PLANNING & ZONING COMMISSION AGENDA
July 19, 2023 at 6:30 PM
Council Chambers

1. Public Hearing for PZ-23-4 and PZ-23-5.
2. PZ-23-4: 225 Guy Street (Parcel #04-00230.000); Rezoning of 3.82 +/- acres from Restricted Industrial District ("I1") to Community Business District ("B2"); and, PZ-23-5: 265 Jefferson Street (Parcel #04-00503.001); Rezoning of 6.94 +/- acres from Restricted Industrial District ("I1") to Community Business District ("B2"); Applicant: Steven D. Bell.
3. PUD-23-7: Preliminary Development Plan, The Spot, Perry Pike Development LLC.

PLANNING & ZONING COMMISSION MINUTES
June 21, 2023 at 6:30 PM
Council Chambers

FIGURE 3

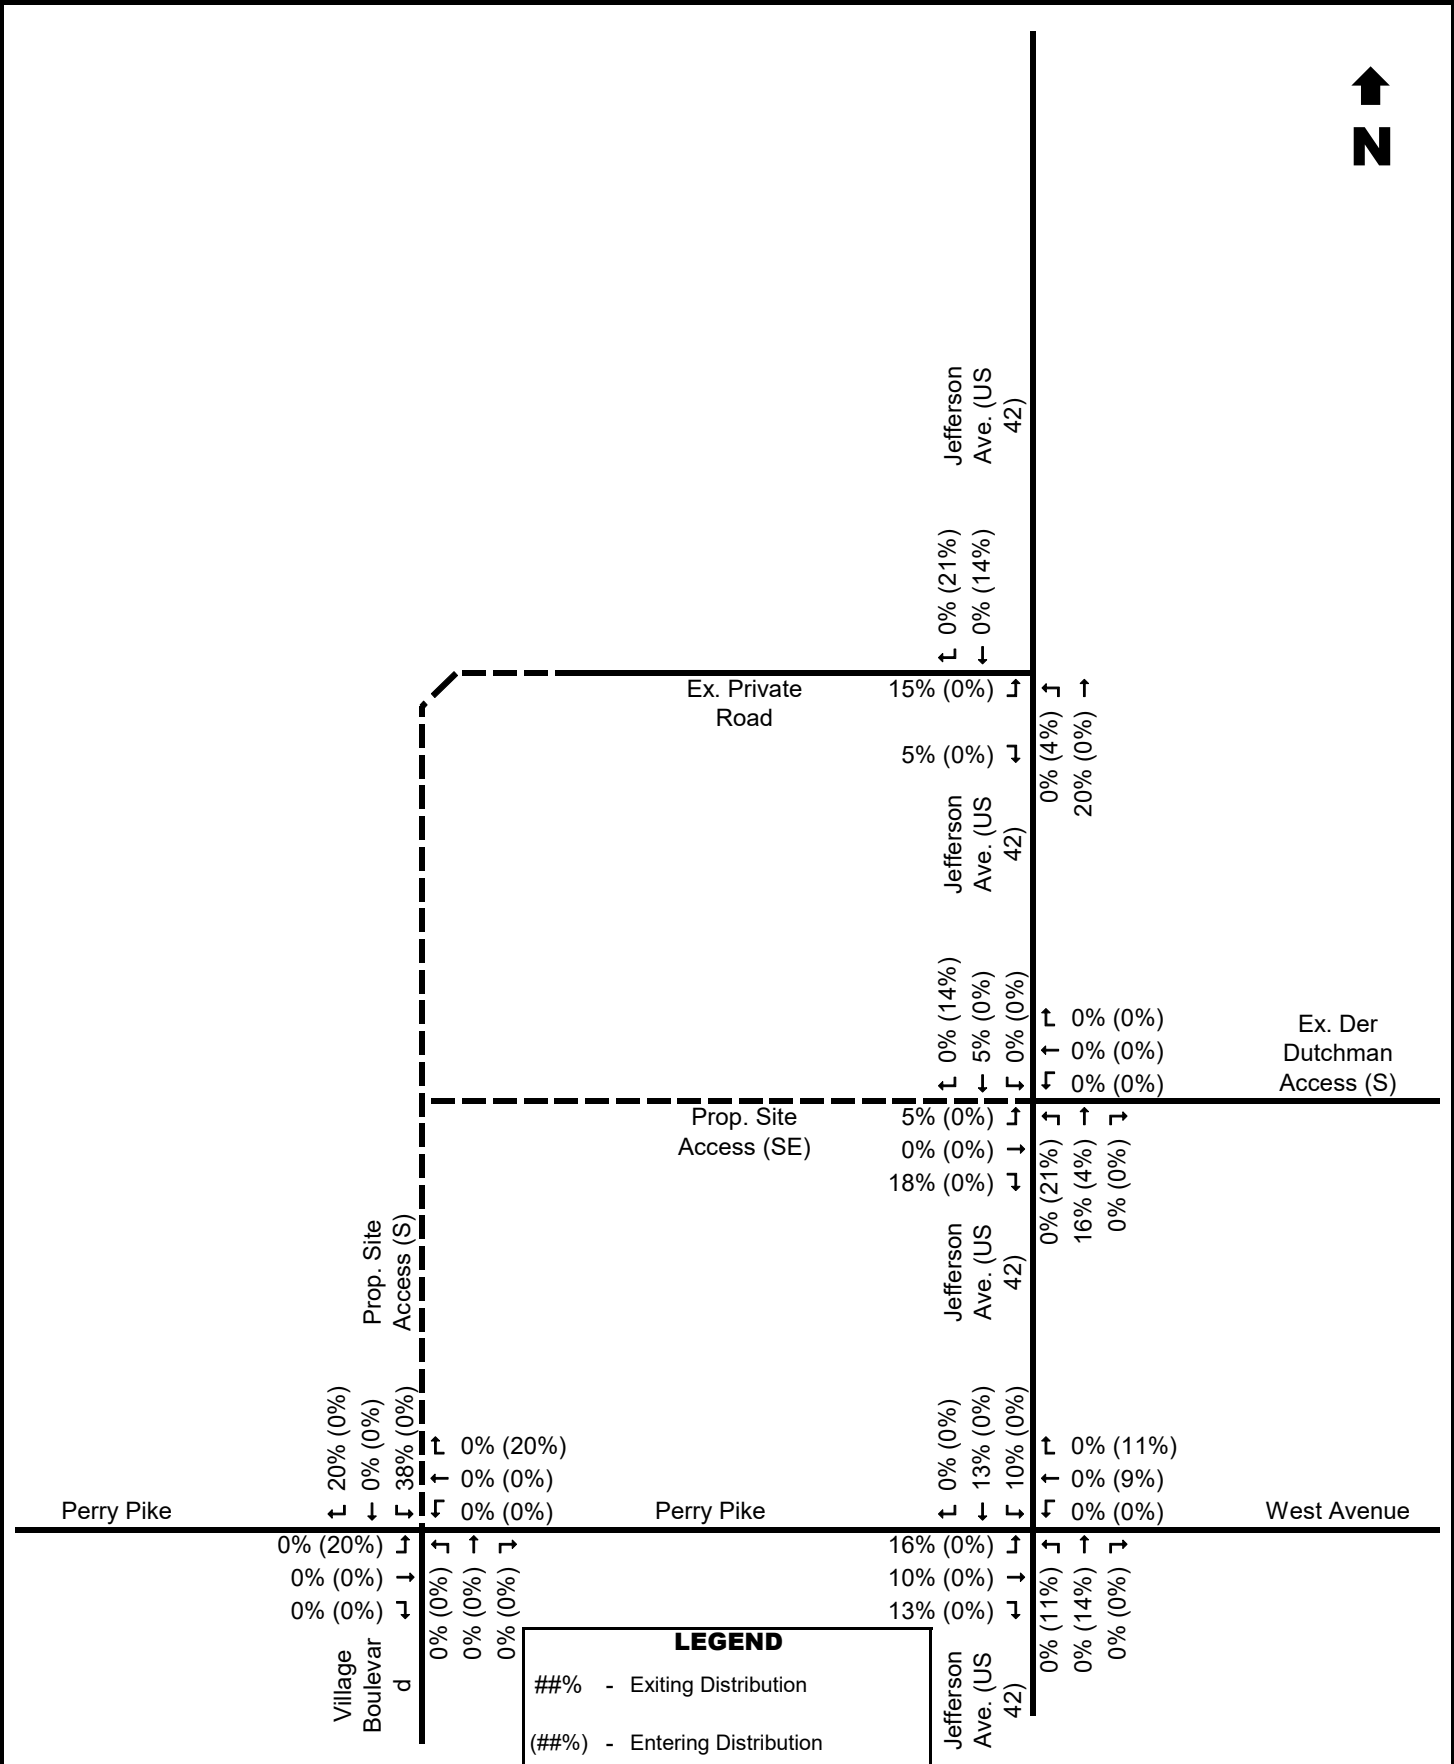
80. Trip Distribution: Referencing Figure 3, the site entering traffic is 53% from the Jefferson Avenue site drive and 47% Perry Pike site drive. The site exiting traffic does not follow the same distribution with 32% exiting the Jefferson Avenue site drive and 68% exiting the Perry Pike site drive. Also in consideration that the highest site generators (the 2 restaurants) generate 82% and 65% (AM and PM) of the site traffic and are expected to be situated near Jefferson Avenue, hence suggesting that more than half of the site traffic would use the Jefferson Avenue site drive. The report should discuss the reasoning behind the site traffic distribution. Site entering and exiting trips should be rechecked to the trip generation table for the primary trips and passby trips as our sums were not equating between the traffic figure and the trip generation table. Any changes in site traffic volumes may affect lane warrants and operational analyses.
